**PLANNER'S REPORT FOR PLAN CHANGE 94 – WASHER ROAD BUSINESS PARK****File Number:** A4524970**Author:** Anna Price, Senior Consents Planner**Authoriser:** Rachael Davie, General Manager Strategy and Community**INTRODUCTION**

1. The purpose of this report is to provide recommendations on submissions and further submissions to Plan Change 94 – Washer Road Business Park.

Figure 2: Proposed changes to Planning Map U125 to include land within the Industrial Zone (shown purple).

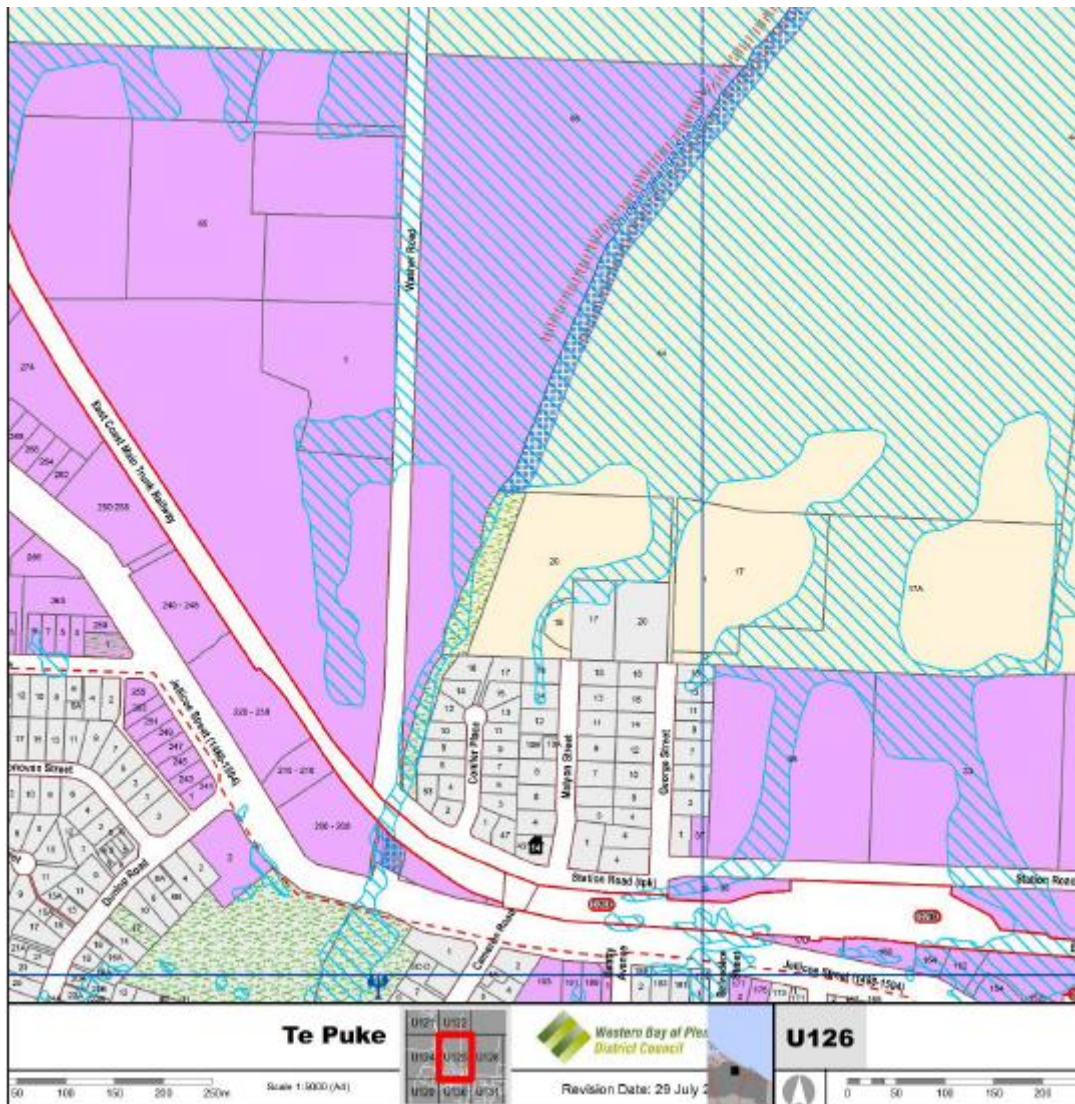
Submission 1.2 – Supports the proposed rezoning of the site to Industrial Zone as it will provide much needed industrial land in Te Puke.

The preferred option is Option 1.

That the land be re-zoned from Rural to Industrial as notified.
